## Author's response to referee comments on the manuscript "Powering aircraft with 100% sustainable aviation fuel reduces ice crystals in contrails" (egosphere-2023-2638)

### Referee #1 (comments to author)

Figure 1: (a) Ice particle size distributions (PSD) as shown in the manuscript in absolute values and with linear y-axis. (b) Histogram of  $R^2$  coefficient of determination for lognormal fits to the shown PSDs.

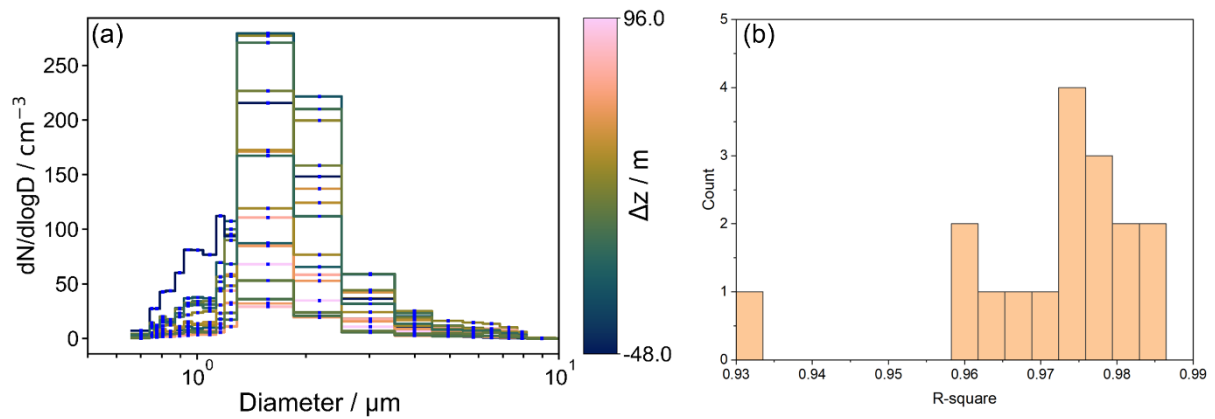
**C2:** The analysis in section 3.4 is quite interesting. It highlights the level of detail of what is known about the flow-field/microphysics interaction, especially regarding the secondary wake and the contrail particle properties there. Figure 5 is quite illuminating, with 5(b) a very nice way to show a trend that is hard to discern as clearly in the main figure (a). In this regard, the authors may wish to note in more detail the changing shape of the size distribution. While many naturally occurring size distributions tend to have log-normal shapes (perhaps due to a central-limit sort of behavior of many competing random processes), a log-normal shape is not physically imposed. And, in this case of the secondary wake, this is a very clear example of the distribution being NOT log-normal and, in fact, the shape is changing across the range of  $\Delta z$  in the secondary wake (otherwise, if the distribution was always log-normal, with the normalization in (a), the curves would all lie on top of one another). The authors may wish to emphasize that the resulting contrail particle size distributions are not log-normal, which has also been observed in some  $\mu$ physical modeling as well.

The referee highlights that section 3.4 and figure 5 provide insights into the changing shape of ice particle size distributions with the range of  $\Delta z$  in the secondary wake. It is pointed out that the observed size distributions deviate from ideal log-normal shapes. We agree with the referee's assessment that the shape of the presented ice particle size distributions changes with  $\Delta z$ . While lognormal distributions are found in aerosol size distributions (Moore et al., 2017), this is not necessarily the case for ice particle size distributions (Kleine et al., 2018; Voigt et al., 2021).

However, we would like to point out that the size distributions in the manuscript are shown with double-logarithmic axes and normalized to the bin of highest number concentration in order to highlight the changes in particle size distribution shape. While this type of representation has its benefits in presenting details at lower number concentrations, it might not be the easiest representation to compare to lognormal distributions. Below in Figure 1 (a) we show the same data but in absolute number concentration values and with a linear y-axis. In this axis representation, a lognormal distribution would appear as a classical Gaussian curve shape and it becomes clear that the size distributions in fact do not deviate too much from the shape of a lognormal distribution. To verify this, we conducted lognormal fits to these size distributions and the  $R^2$  coefficients of determination of these fits can be seen in Figure 1 (b). For lognormal fits of all shown size distributions,  $R^2$  values of over 0.96 are achieved for all distributions except for the one at lowest  $\Delta z$ , which also visually deviates the strongest from the other distributions. This size distribution is fitted lognormally with a  $R^2$  of 0.93. We can therefore conclude that the shown size distributions have varying deviations from perfect lognormal distributions with  $\Delta z$  while they are generally approximated well by lognormal function fits.

- Referee #2 C2: Added a sentence to 3.4 to briefly discuss the deviation from lognormal size distributions.
